# ELECTRICAL INSTALLATION CONDITION REPORT

Report Reference: 1144

Client: Kings Hill Parish Council  
Address: 70 Gibson Drive, Kings Hill, Kent, ME19 4LG

Reason for producing this report:  
Insurance company request.

DB2

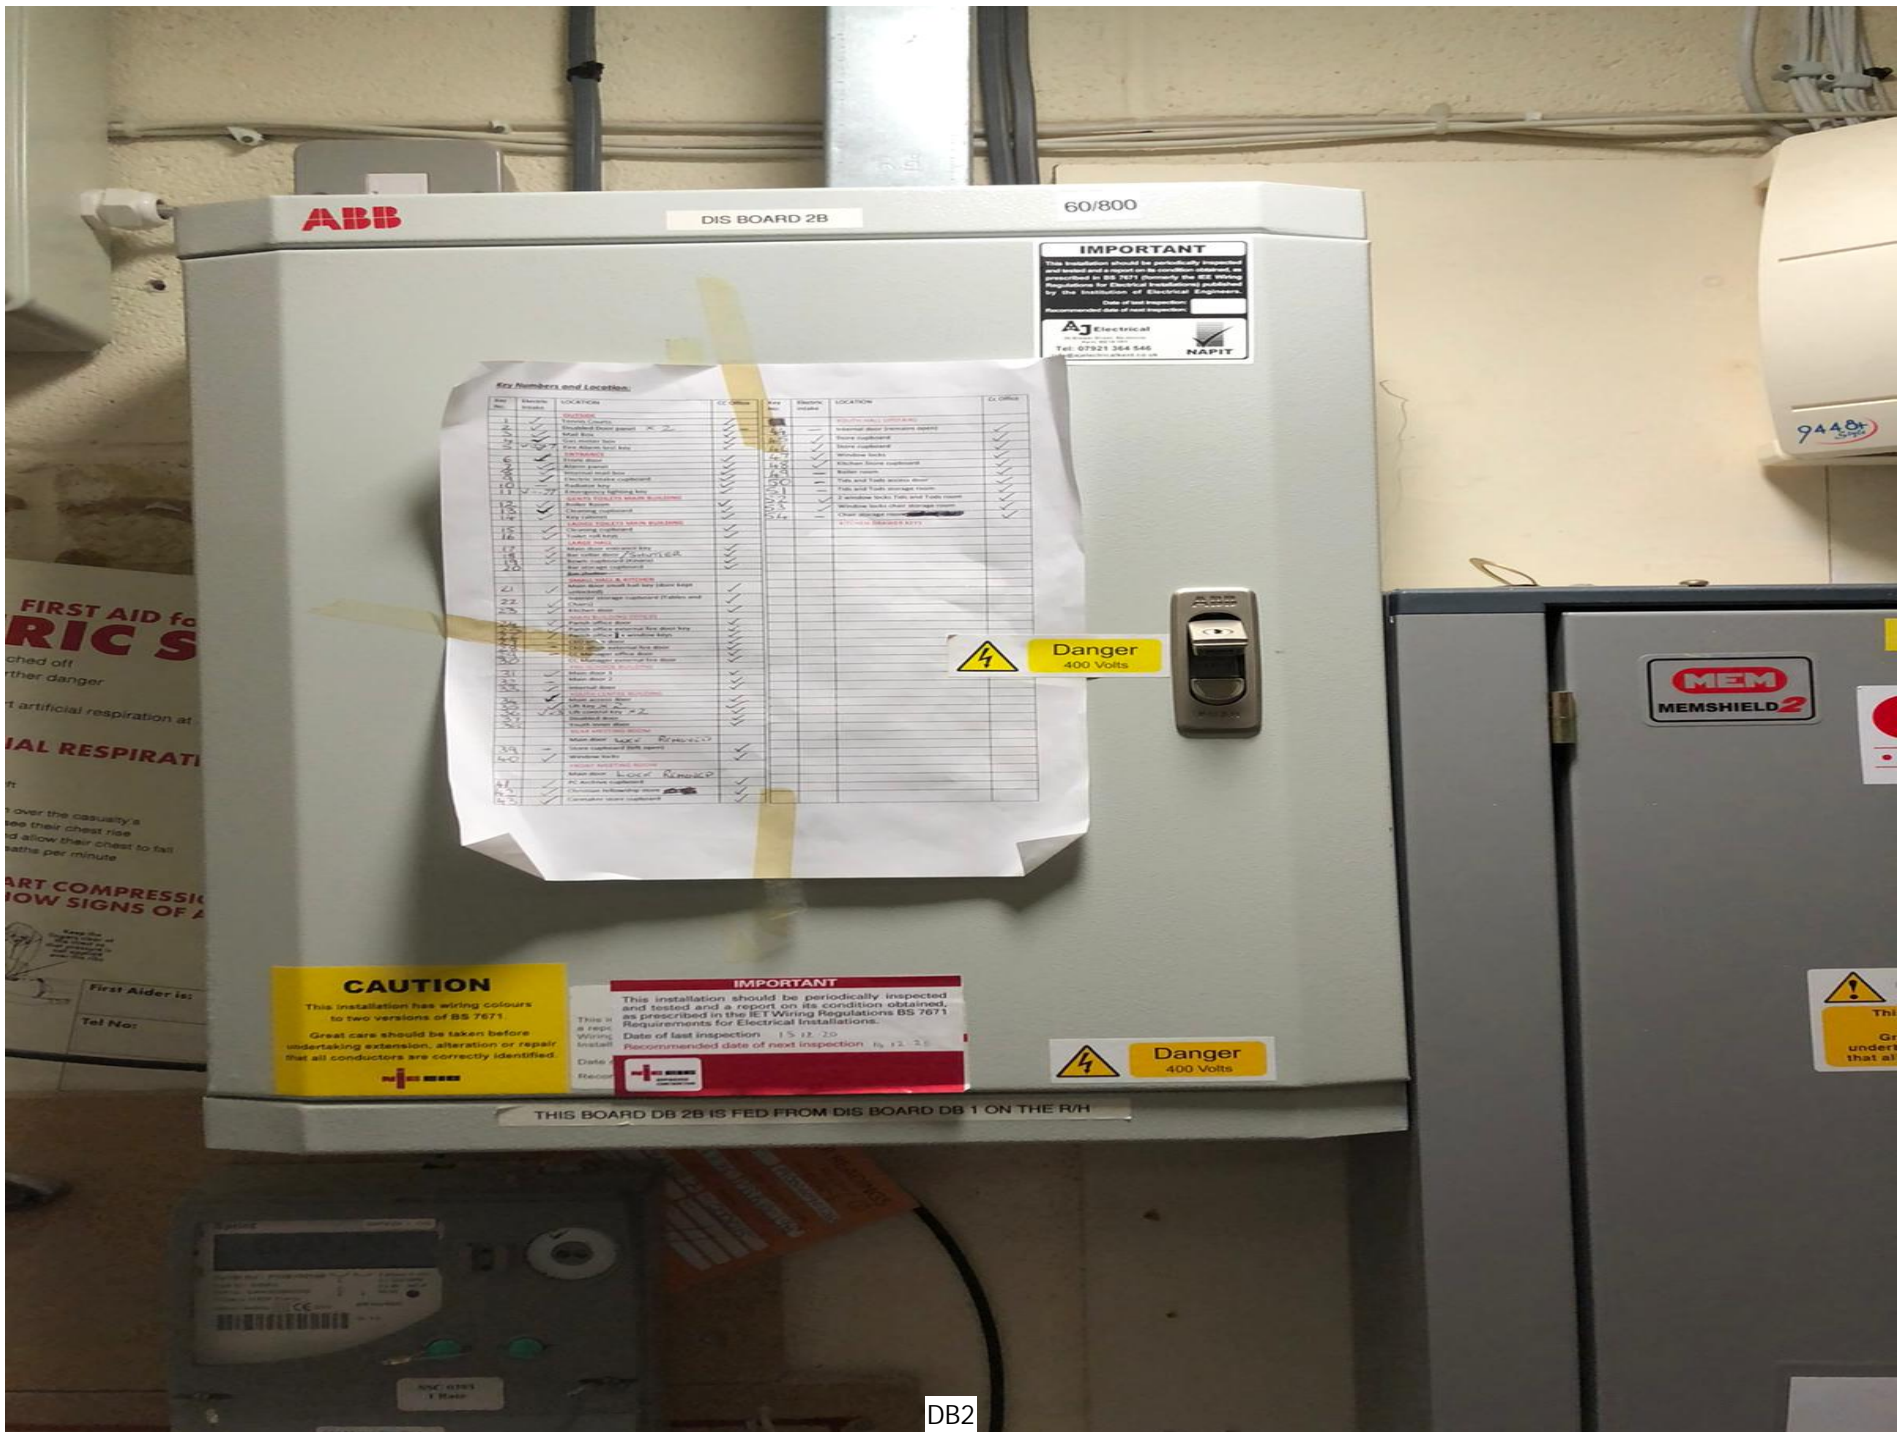
Item No	Observations	Classification Code
1	Inspection Schedule Item 5.5: Condition of enclosure(s) in terms of IP rating etc (416.2) is recommended for improvement. Incorrect RCBOs used for DB2 - cover does not sit correctly on enclosure.	C3
2	Inspection Schedule Item 9.7.2: Installed to minimise build-up of heat by use of fire rated fittings, insulation displacement box or similar (421.1.2) is recommended for improvement. Non fire-rated downlights used in bar area.	C3
3	Inspection Schedule Item 5.21: Compatibility of protective devices, bases and other components; correct type and rating (no signs of unacceptable thermal damage, arcing or overheating) (411.3.2; 411.4; 411.5; 411.6; Sections 432, 433) is recommended for improvement. Incorrect RCBOs (wrong brand) used in DB2.	C3
4	Damaged RCBO on DB2/4L1.	C3
5	No RCD protection for DB1/11L2.	C3
6	Broken lugs/bolts on trunking lids in electrical cupboard.	C3

Installation has been completed to a good standard. I would however comment on recent works to DB2 - incorrect RCBOs used (wrong brand) for the distribution board (DB), and thus doesn't allow the cover to sit on the DB correctly. Broken RCBO on DB2 - would advise replacing.
